# Charlotte Historic District Commission

## Agenda Supplement

February 11, 2026

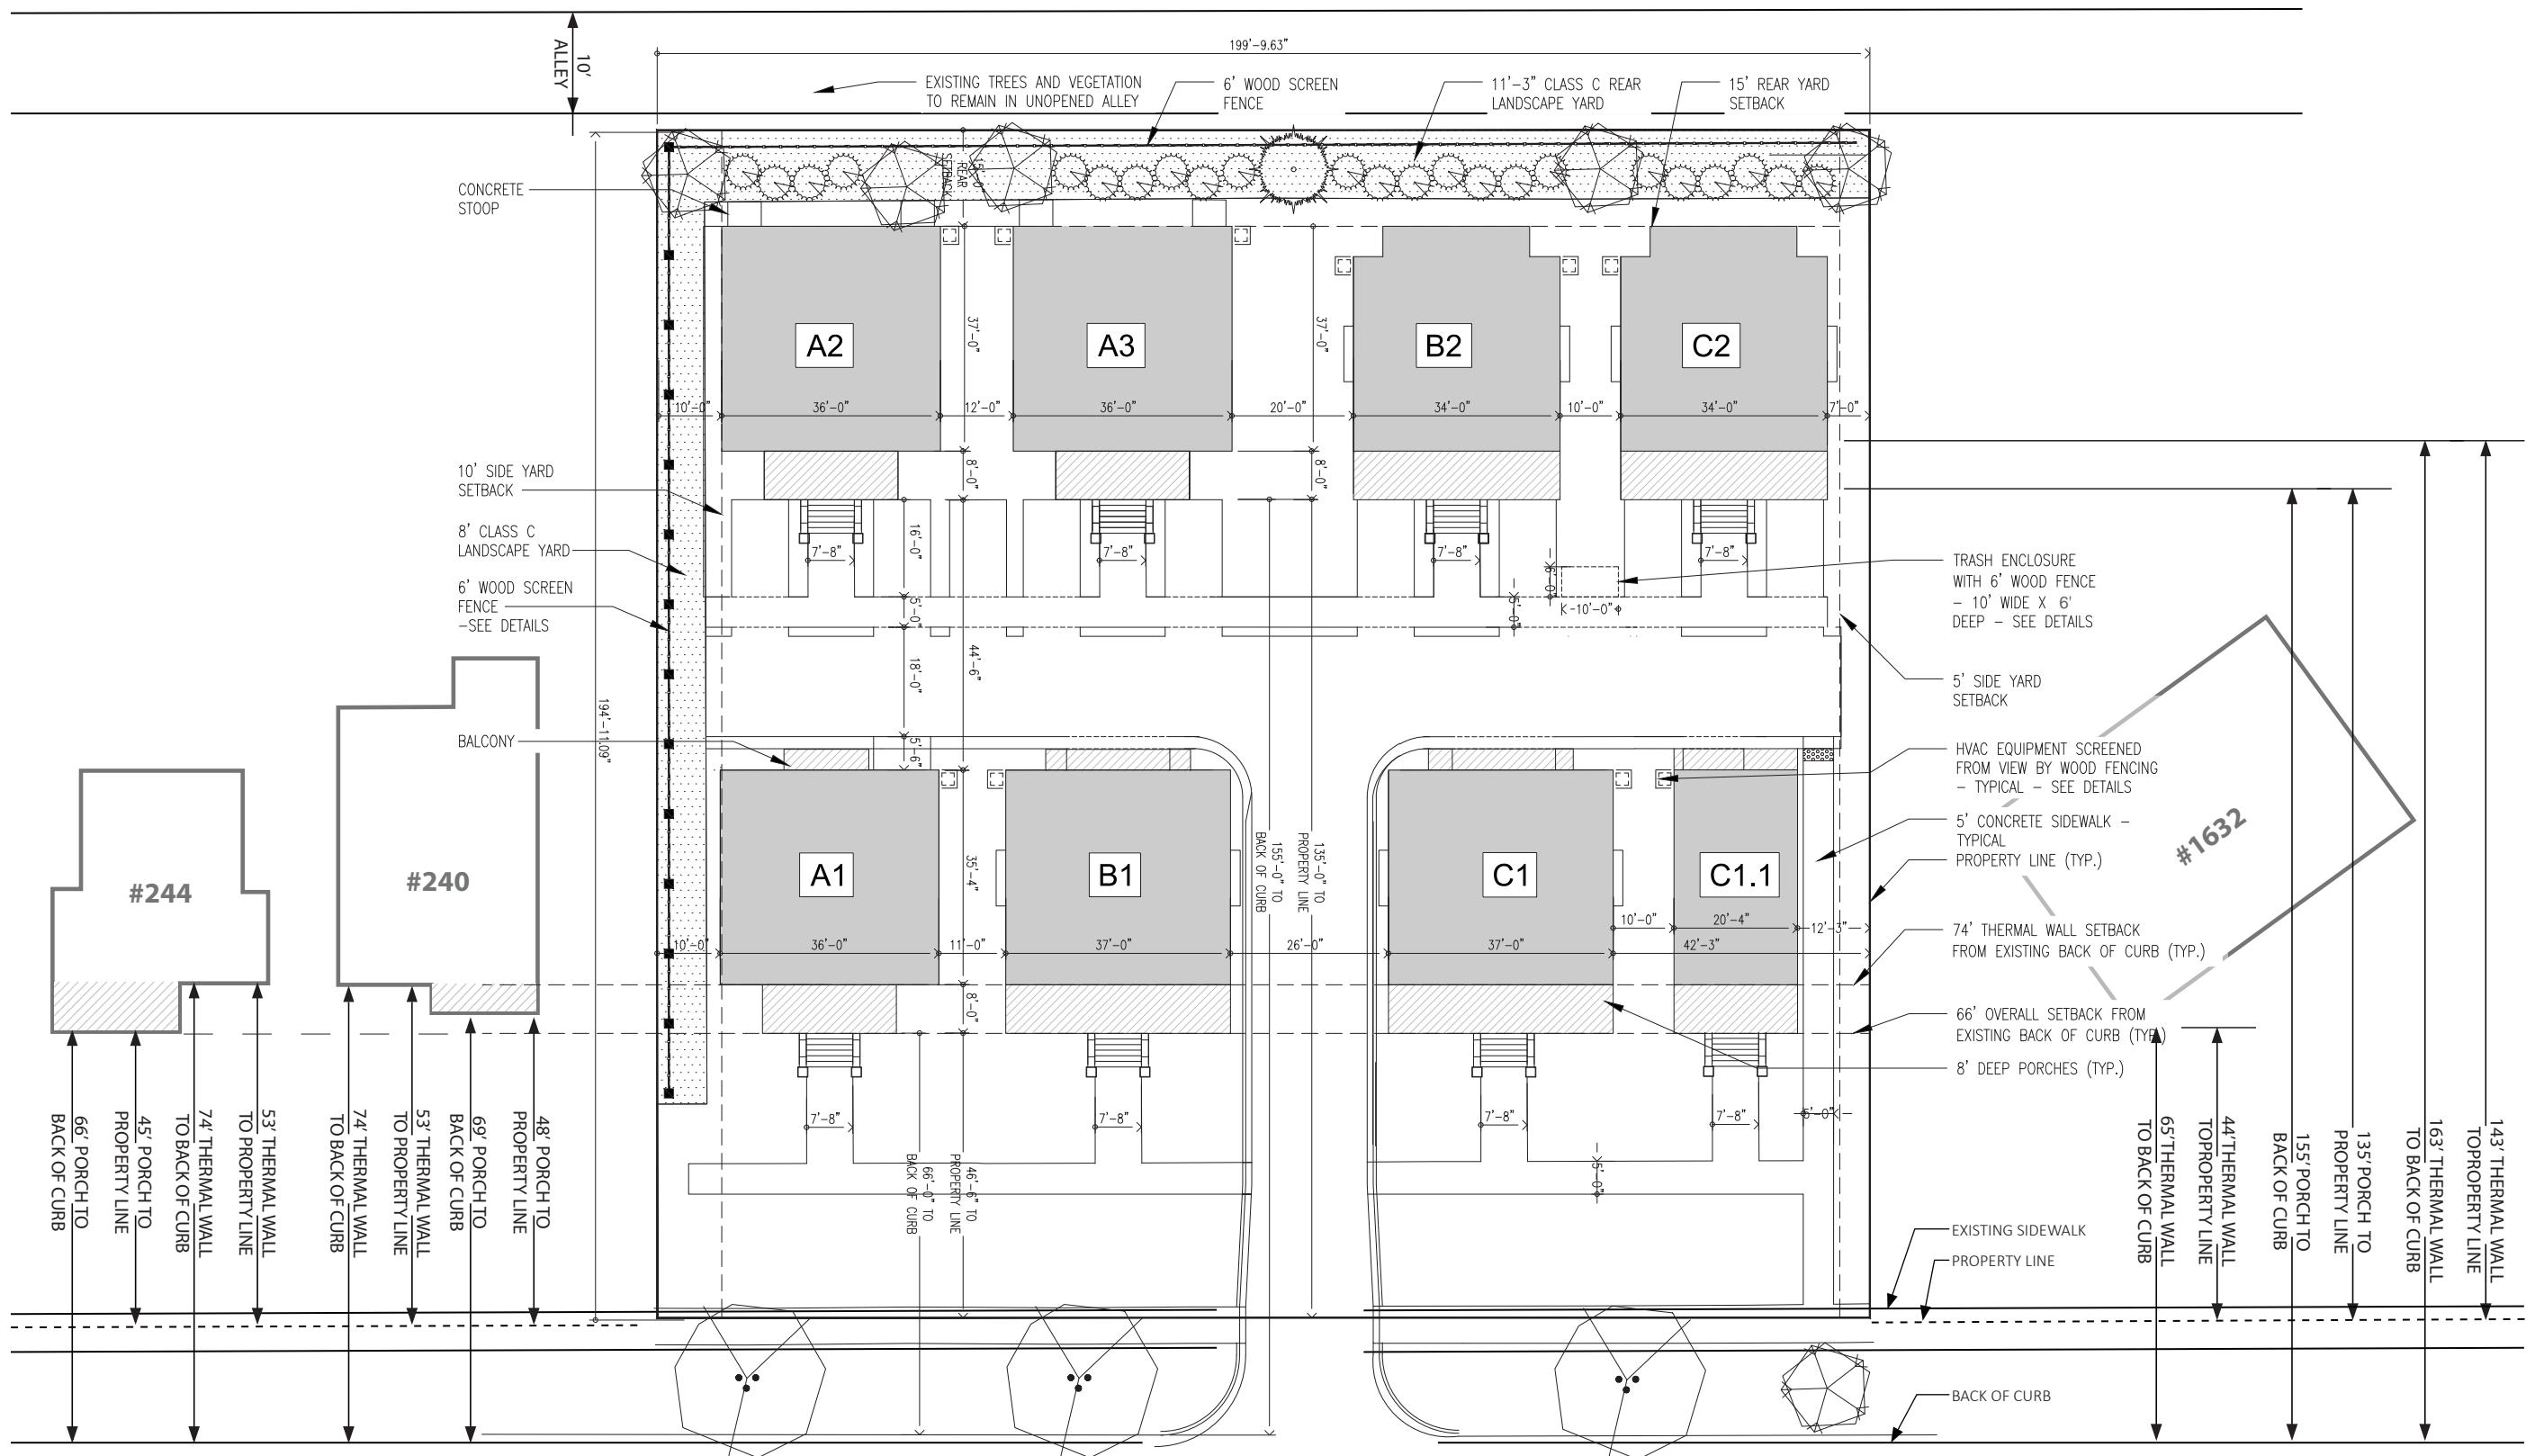
- i. Consider moving the 6'-0" fence along the left property line to right property line.

- ii. Fencing along the left property line should follow the approved HDC stepdown.

The fencing along the left property line as depicted is a zoning requirement at that specific location.

Fencing will follow the approved HDC stepdown.

**SOLID WOOD SCREEN AT TRASH ENCLOSURE  
6' WOOD FENCE**

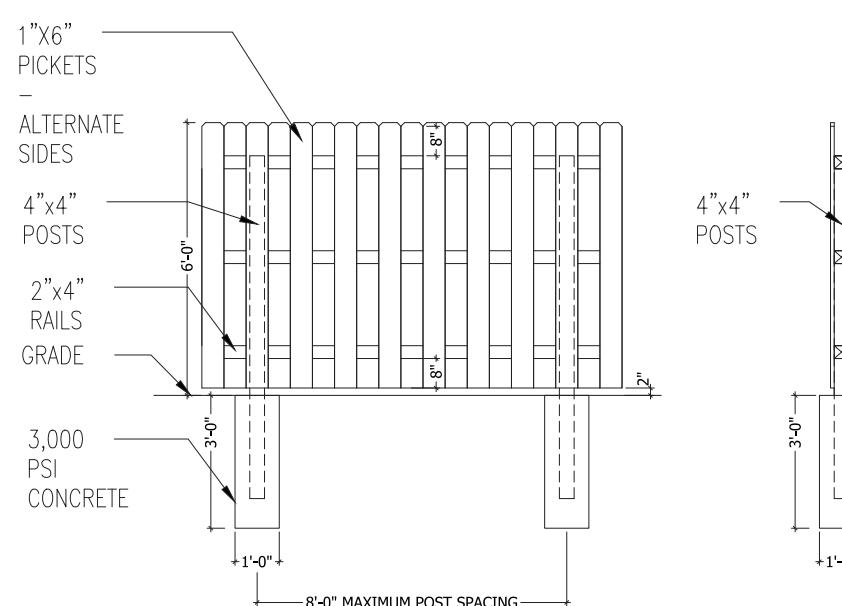
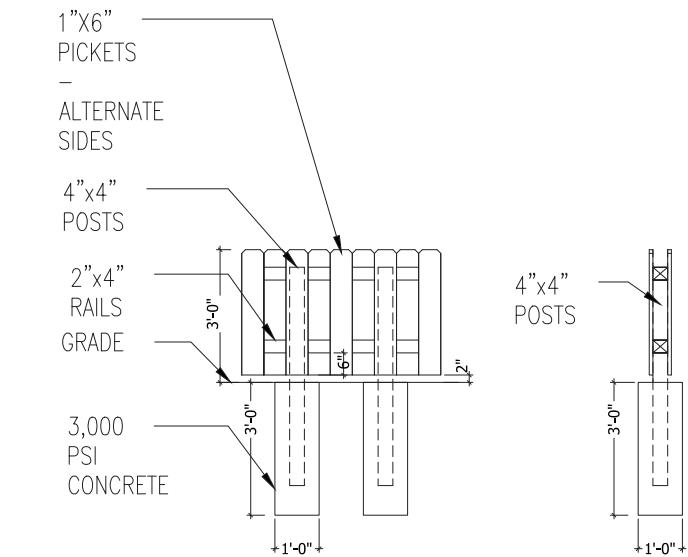
- iii. Add fencing details to architectural details page.

Wood fence detail is the same as for the 6'-0" trash enclosure on pg A-29.
